CITY OF SEASIDE
BOARD OF ARCHITECTURAL REVIEW

A. **Board of Architectural Review Application No. BAR-11-10: The City of Seaside,**

Item No.: 6.A.

SUBJECT: **Board of Architectural Review Application No. BAR-11-10:** The City of Seaside, applicant, is requesting final approval of the architectural design for the proposed West Broadway Urban Village Infrastructure Improvements Plans. The project site is located within the public right-of-way on Broadway Avenue between Del Monte Boulevard and Fremont Boulevard and on Del Monte Boulevard between Canyon Del Rey Boulevard and Olympia Avenue within the West Broadway Urban Village Specific Plan Area. In compliance with Section 15164 of the California Environmental Quality Act (CEQA), an addendum to the West Broadway Urban Village Specific Plan Final Environmental Impact Report was approved by the City of Seaside City Council on February 16, 2012 (Resolution No. 12-17).

PHASE I - STREETSCAPE MASTER PLAN

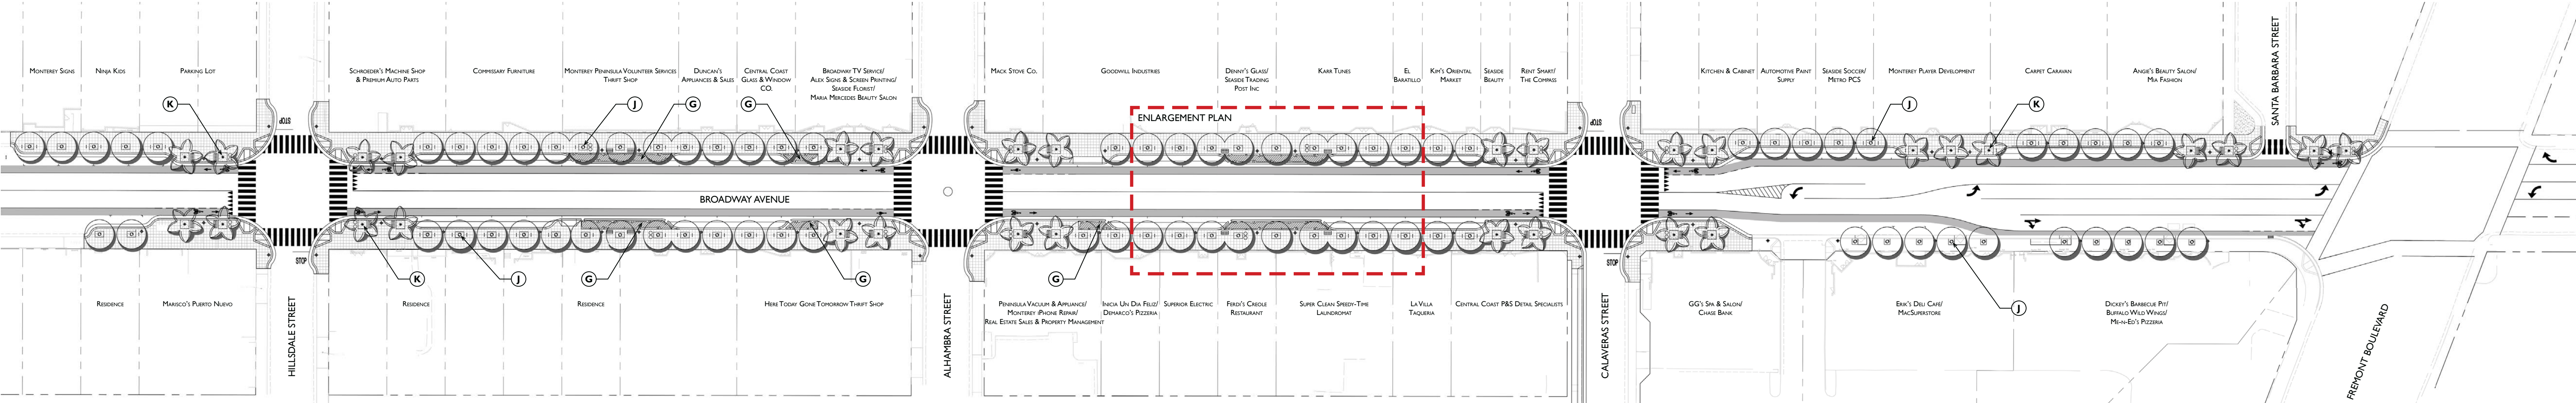
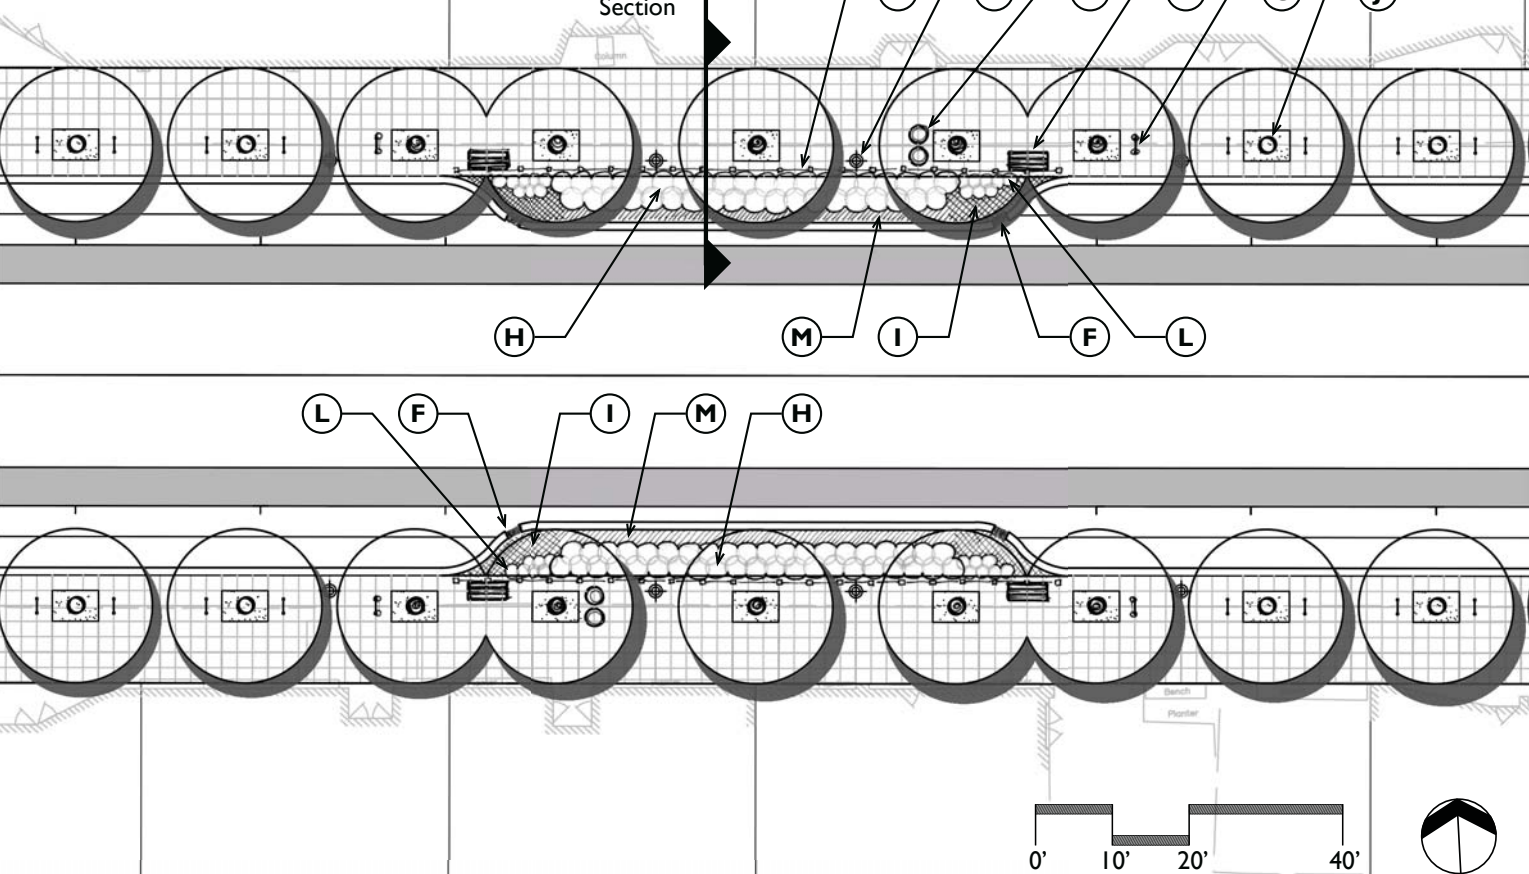
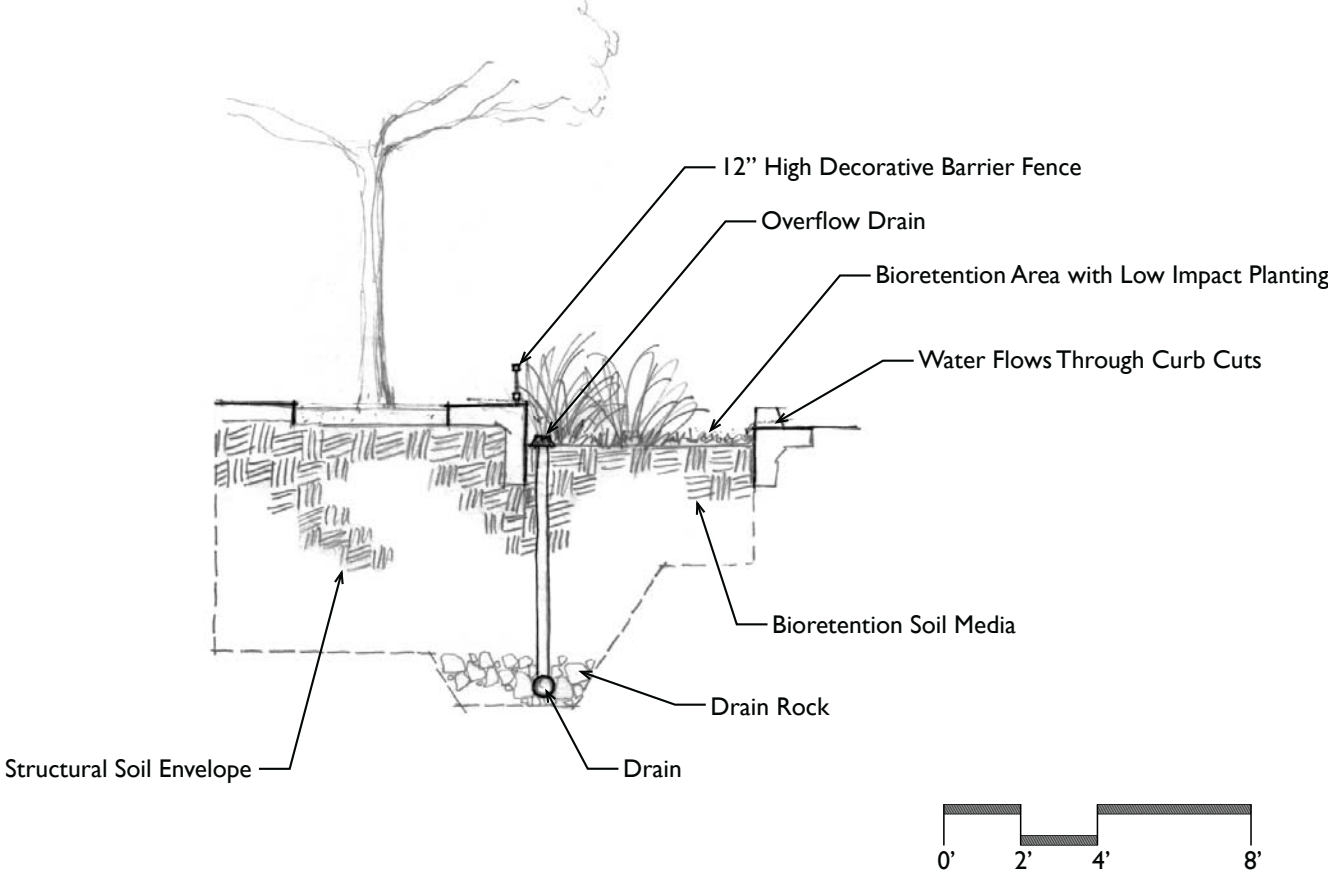
Board member Ventimiglia – State that she was in favor of the overall concept but expressed concerns with the use and number of the liquid amber trees being proposed. She suggested that the City initially plant a few trees in order to test how well they grow and adapt to West Broadway corridor before fully implementing the planting plan.

Discussion ensued amongst the Board regarding the appropriate number of trees and spacing of trees within the streetscape. A "New Zealand Christmas" tree was discussed as an alternative to the use of a palm tree. Boris Dramanov informed the Board that the Washingtonia Palms were picked as the replacement based on their canopy beginning at 15-20 feet which would allow for visibility to the storefronts. The use of palms also provides a more open appearance that would provide sunlight to the storefronts and streetscape as well. Diana Ingersoll, Deputy City Manager – Resource Management Services, advised the Board that they could vote to approve the West Broadway Urban Village Improvement plan with the condition that the type of tree that would be used would come back to the Board for final approval prior to any trees being planted. She explained that there is some urgency in receiving approval on the construction plans so

Medjool Date Palms (*Phoenix dactylifera* ‘Medjool’) with 25-foot brown trunk will be placed at intersection and mid-block bulb-outs. New Zealand Christmas Trees (*Metrosideros excels*), which are now being proposed to replace Mexican Fan Palms (*Washingtonia robusta*), will be placed curbside along West Broadway Avenue to provide a continuous canopy and pedestrian scale.

the City of Seaside Municipal Code regarding landscaping and outdoor lighting. In accordance with the BAR direction, staff is proposing that the New Zealand Christmas Tree (*Metrosideros excels*) replace the Mexican Fan Palm (*Washingtonia robusta*). The attached Exhibit A to Attachment 1 shows the proposed location and number of trees for the first phase of this project. The New Zealand Christmas Trees (*Metrosideros excels*) will be placed curbside along West Broadway Avenue to provide a continuous evergreen canopy in contrast with the Medijool Palm Trees being placed at intersection and mid-block bulb-outs. Additionally, under the Active Transportation Program (ATP) grant, the shade canopy of the New Zealand Christmas Trees would qualify the City to obtain a reimbursable cost for these trees as the shade canopy is classified as a functional benefit to the community. The Mexican Fan Palm is classified as a decorative tree which would not qualify for grant reimbursement.
